31 March 2025

SUBMISSION TO CASEY FIELDS SOUTH (EMPLOYMENT) AND DEVON MEADOWS PSP

Figure 1: SIG Group Landholding

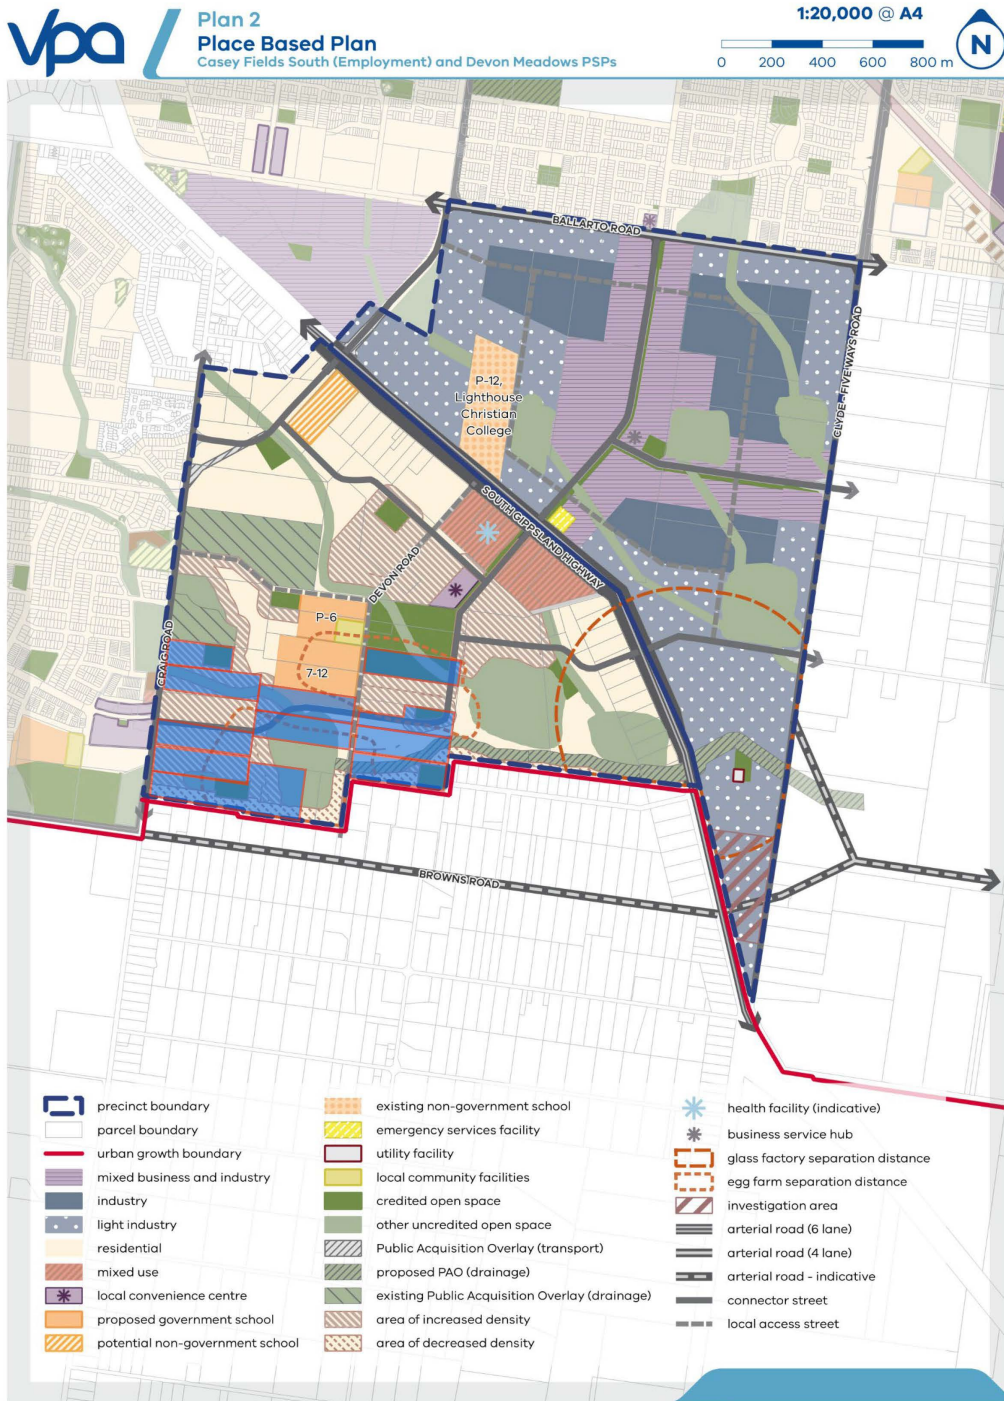
SIG Group represent a total of 11 land parcels of land within this PSP. These land parcels are identified as Properties DM-48, DM-66, DM-69, DM-70, DM-72, DM-73, DM-74, DM-75, DM-78, DM-79 and DM-80 within the PSP, as identified in Figure 1 below.

The ability to develop the southern sections of properties DM-78 and DM-80 needs to be re-considered. These areas could be landlocked due to barriers posed by the position of waterways and open space reserves, limiting the ability to connect to Devon Road and Craig Road respectively. Similarly, consideration should be given to the residential outcomes that may be possible having regard to access opportunities and the dimensions considered available for development.

The same can be said for parts of properties DM-69 and DM-70 which are cut off by the proposed waterway alignment.

The PSP identifies four local parks (DM-LP-05, DM-LP-07, DM-LP-08 and DM-LP-09) to be provided across our various landholdings. Whilst we are supportive of the provision of amenity within the precinct, we would like to reserve the ability to revisit the distribution of open space within the precinct.

Whilst the PSP identifies a portion of the active open space (DM-SR-01) to be delivered on one of our landholdings. We submit that we would like to review the quantum, alignment and need for the active open space at this location.

The PSP identifies multiple drainage assets (DM-RB-04 and DM-RB-05) and waterways within our landholdings. The suitability of the waterway alignments and the quantum of wetlands required for the precinct should be revisited.
